The Plantations, Preliminary Plan -120090240

Staff Report Date: 06 /8/12

Request to subdivide parcel 728 (24320 Woodfield Road), into two (2) lots; located on the west side of Woodfield Road (MD124), approximately 200 feet south of the intersection of Log House Road; 1.65 acres; R-200 Zone; Damascus Master Plan Area.

PRELIMINARY FOREST CONSERVATION PLAN
THE PLANTATIONS
(PARCEL 728; TAX MAP FW343)
Montgomery County, Maryland

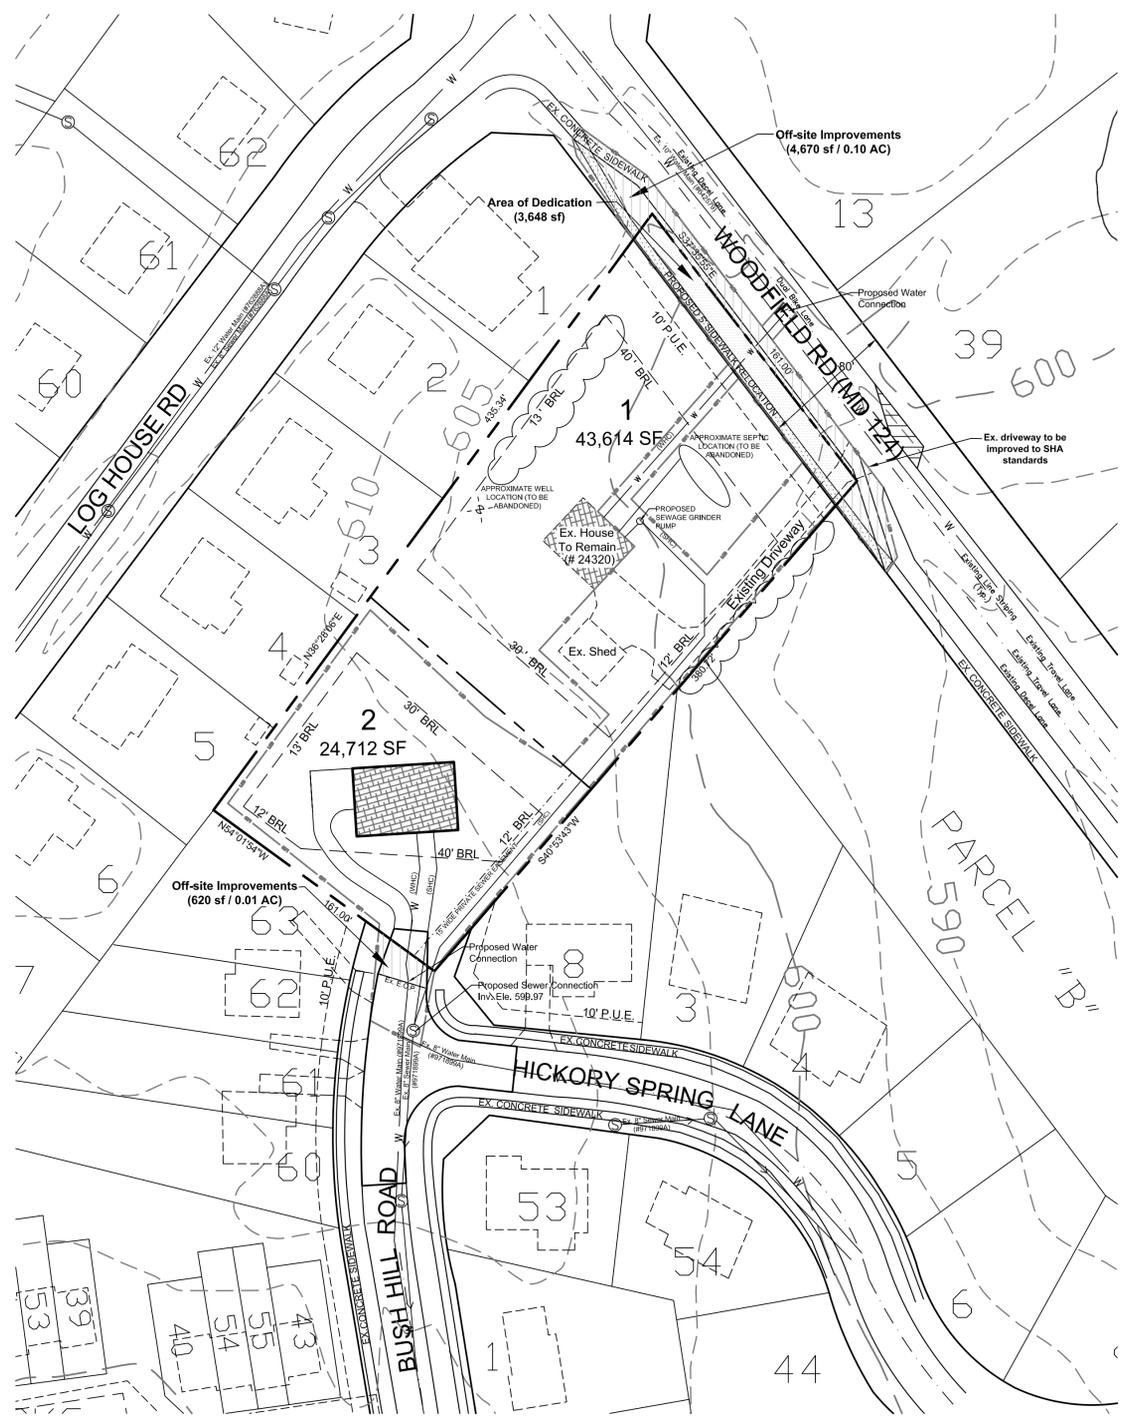
Development of the Property requires that it comply with the Montgomery County Forest Conservation Law, Chapter 22A of the County Code. The submitted forest conservation plan (FCP) (Attachment B) and worksheet shows that there is a 0.26 acre afforestation planting requirement. The Property is classified as being in the High Density Residential land use category where a 15 % afforestation threshold must be met for the net tract area. The Applicant proposes to meet the 0.26 acre afforestation planting requirement through an off-site mitigation bank or Fee-In-Lieu payment to be determined at the time of Final Forest Conservation Plan.

NOTE:
0.26 ACRE AFFORESTATION REQUIREMENT TO BE SATISFIED BY OFF-SITE CREDIT OR FEE-IN-LIEU.
